Safety Defect and Noncompliance Report Guide for Vehicles PART 573 Defect and Noncompliance Report

On , August 31th, 2010, Fontaine Modification decided that a defect which relates to motor vehicle safety exits in the motor vehicles listed below, and is furnishing notification to the National Highway Traffic Safety Administration in accordance with 49 CFR Part 573 <u>Defect and Noncompliance Reports</u>.

Fontaine Modification 9827 Mt Holly Rd Charlotte, NC 28214

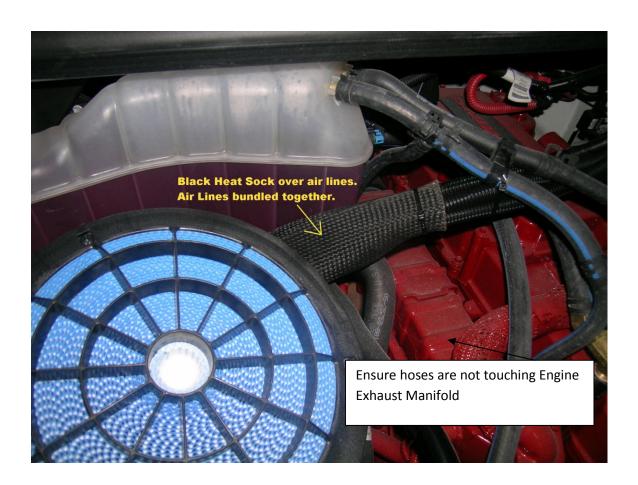
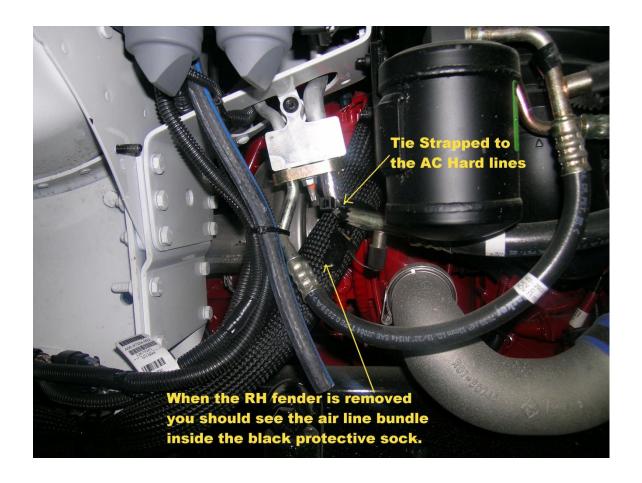
Just after the initial failure was reported on 5/7/10, Fontaine reviewed & revamped the manufacturing process at the Texas location. During July 2010 Fontaine began working with Elgin Sweeper (largest customer with this modification) by providing inspection and repair instructions. Elgin's dealer is TransChicago, and were the ones responsible for conducting the inspections and required repairs. Of the 34 trucks inspected in July and August, none were found with melted air lines; however, the dealer did find approximately half of the trucks did not have the air lines routed properly. These air lines were re-routed and properly tied in place on the trucks with improper routing.

V. Identify the Remedy: The remedy for any melted air hoses is to remove the affected hoses, contact Fontaine Modification for parts, and replace with new hoses and thermal wrap as shown below. For Air Hoses that are improperly routed, the remedy is to route per the

enclosed photos away from hot exhaust components.
